DATE **Jun.30/03****V2500-A1/A5/D5 SERIES PROPULSION SYSTEMS SERVICE BULLETIN**

This document transmits Revision 4 to Service Bulletin EV2500-72-0220

Update Effectivity, revise
References and Family
Trees. To incorporate
intent of SB ENG-72-0267
into this SB.All pages of
Appendix 1Pages 1 to 6 of
Appendix 1Update Effectivity, revise
References and Family
Trees. To incorporate
intent of SB ENG-72-0267
into this SB.**V2500-ENG-72-0220**

ENGINE – HP TURBINE ROTOR AND STATOR ASSEMBLY – INTRODUCE NEW FIRST AND SECOND STAGE
TURBINE BLADES WITH MORE DURABLE TIPS AND IMPROVED REPAIRABILITY

Location of the Stage 1 HPT Blade.
Figure 1

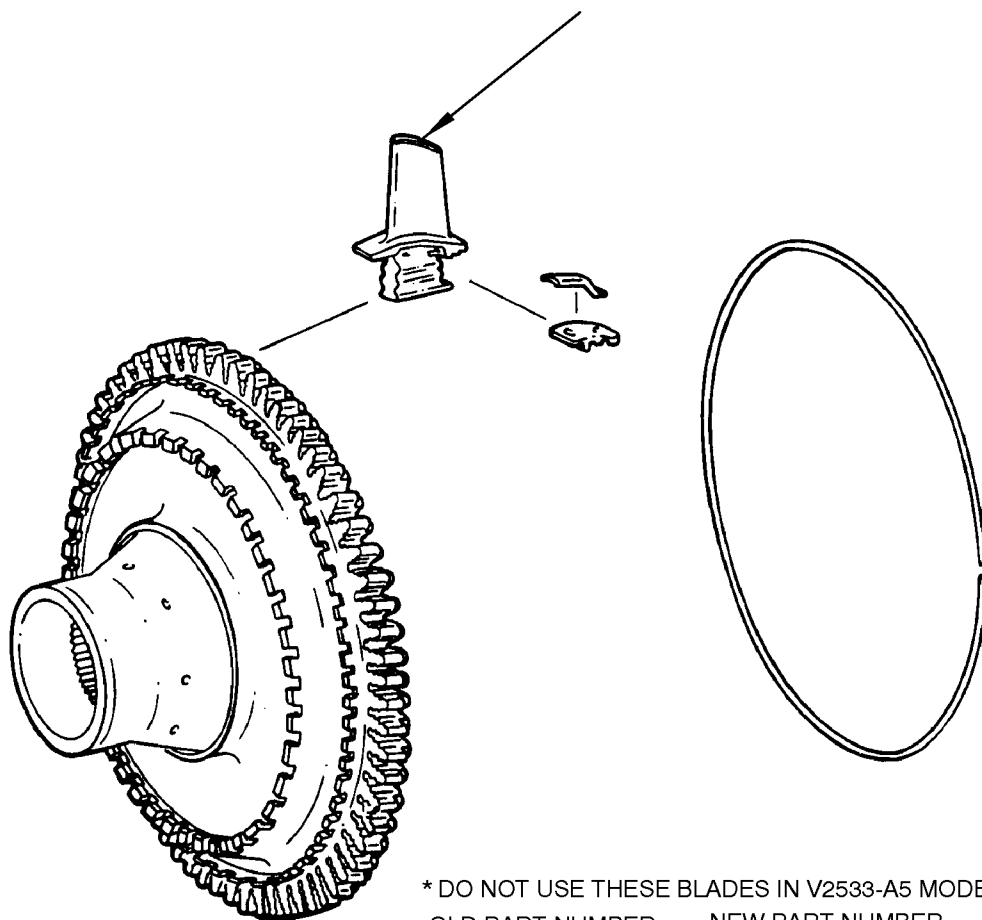
REPLACE THE STAGE 1 HPT BLADE
WITH THE APPLICABLE NEW
STAGE 1 HPT BLADE

* DO NOT USE THESE BLADES IN V2533-A5 MODELS

OLD PART NUMBER	NEW PART NUMBER
2A3001*	2A3001-001*
2A1221*	2A1221-001*
2A1721*	2A1721-001*
2A2421*	2A2421-001*
2A8521*	2A8701*
2A8321*	2A8321-001*
2A2621*	2A2621-001*

Location of the Stage 2 HPT Blade Assembly.
Figure 2

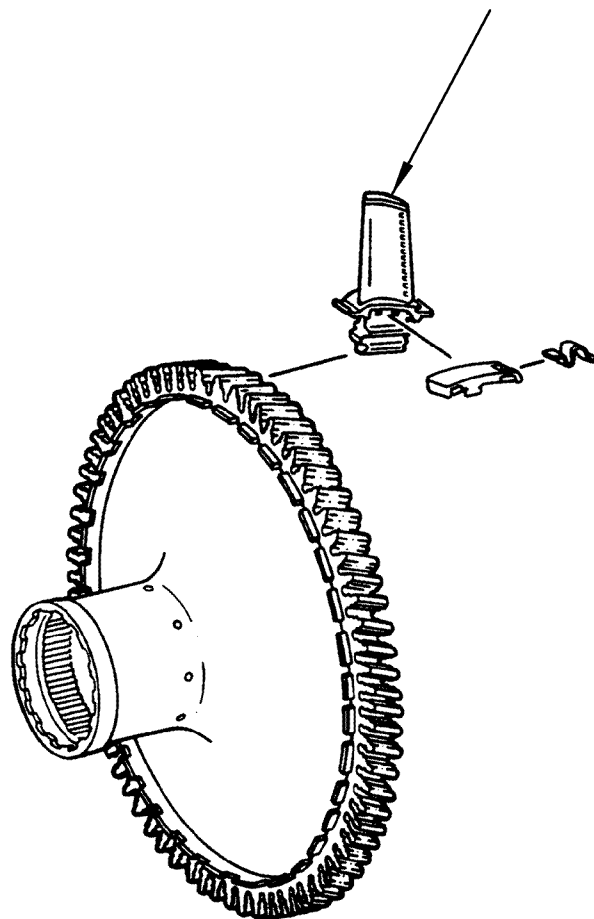
REPLACE THE STAGE 2 HPT BLADE
WITH THE APPLICABLE NEW STAGE 2
HPT BLADE ASSEMBLY

* DO NOT USE THESE BLADES IN V2533-A5 ENGINE

OLD PART NUMBER	NEW PART NUMBER
2A1102*	2A1102-001*
2A0402*	2A0402-001*
2A2202*	2A2202-001*
2A2702	2A8702

Family Tree - Stage 1 HPT Blade (V2500-A1) Ref. Catalogue Sequence No. 72-45-14.
Fig. 01 Item 010.
Figure 3

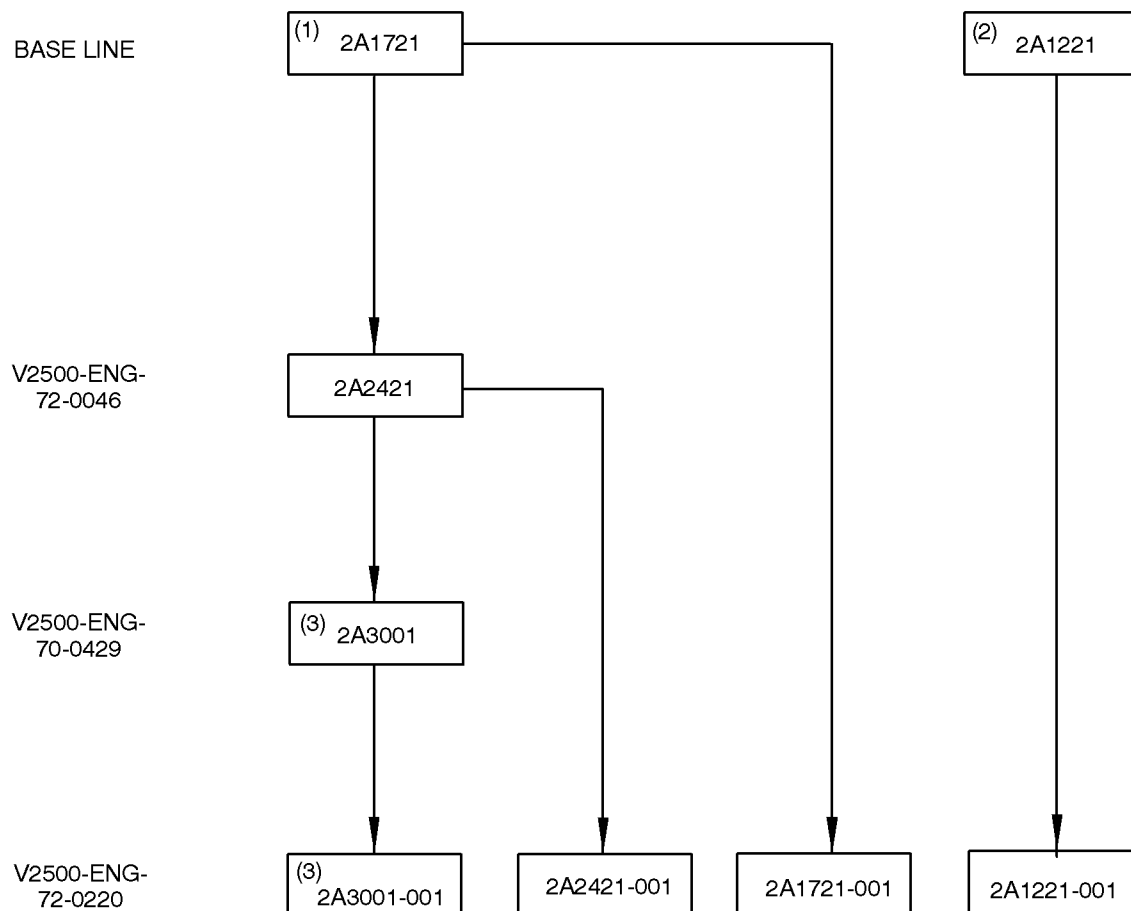
- (1) DOES NOT HAVE PLATFORM COOLING HOLES.
- (2) HAS PLATFORM COOLING HOLES.
- (3) PROGRESSION FOR RECORD PURPOSES ONLY.
FOR V2500-A1 ENGINE SERIAL NO. V0362 AND SUBSEQUENT.

Family Tree - Stage 1 HPT Blade (V2527-A5, V2527E-A5, V2527M-A5, V2530-A5, V2525-D5, V2528-D5) Ref. Catalogue Sequence No. 72-45-14. Fig. 01 Item 010.

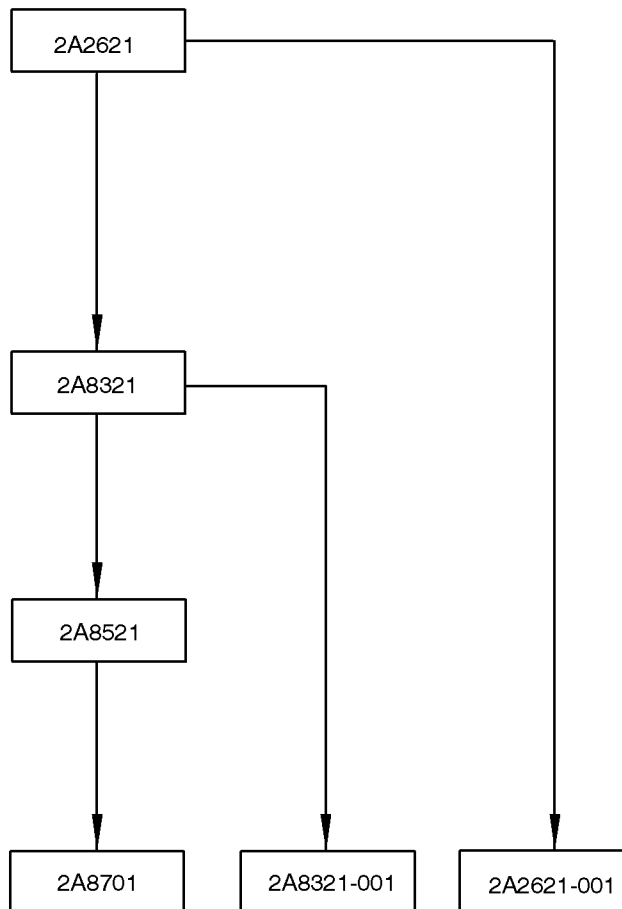
V2500-ENG-
72-0146

V2500-ENG-
70-0379

V2500-ENG-
72-0220

Family Tree - Stage 2 HPT Blade Assembly (V2500-A1) Ref. Catalogue Sequence No. 72-45-32. Fig. 01 Item 010.
Figure 5

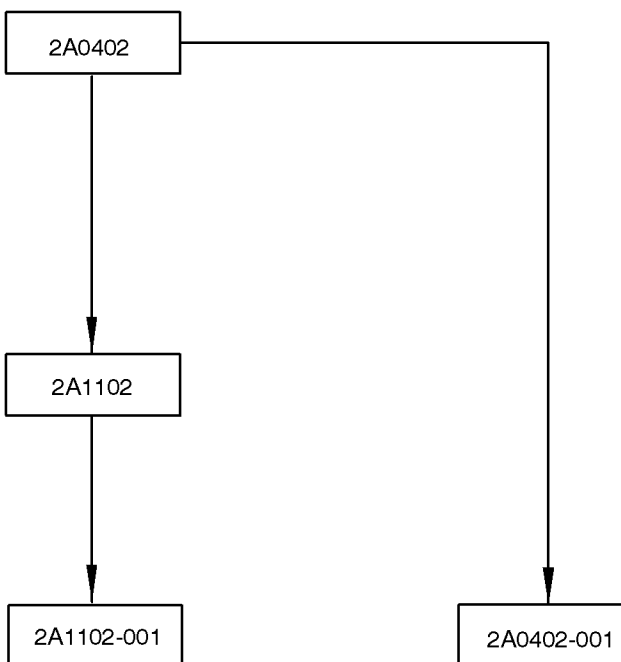
V2500-ENG-
70-0154

V2500-ENG-
72-0220

Family Tree - Stage 2 HPT Blade Assembly (V2522-A5, V2524-A5, V2527-A5, V2527E-A5, V2527M-A5, V2530-A5, V2533-A5) Ref. Catalogue Sequence No. 72-45-32. Fig. 01 Item 010. Figure 6

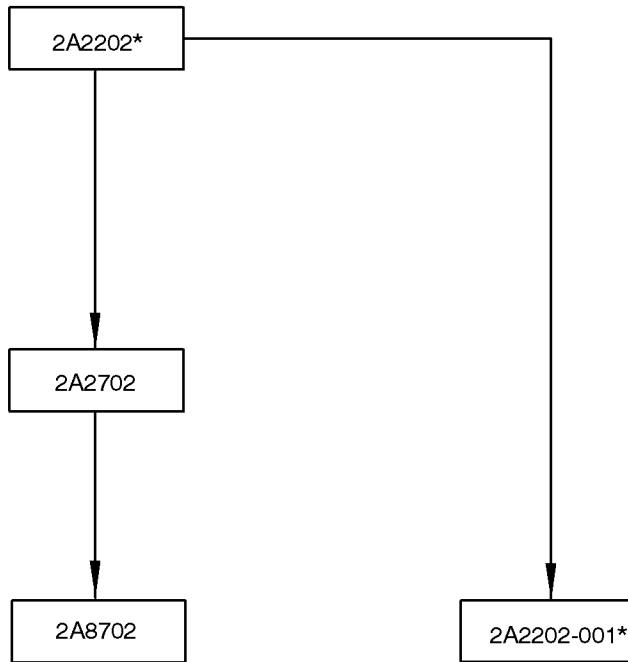
V2500-ENG-
72-187

V2500-ENG-
72-0220

* DO NOT USE IN MODEL V2533-A5.
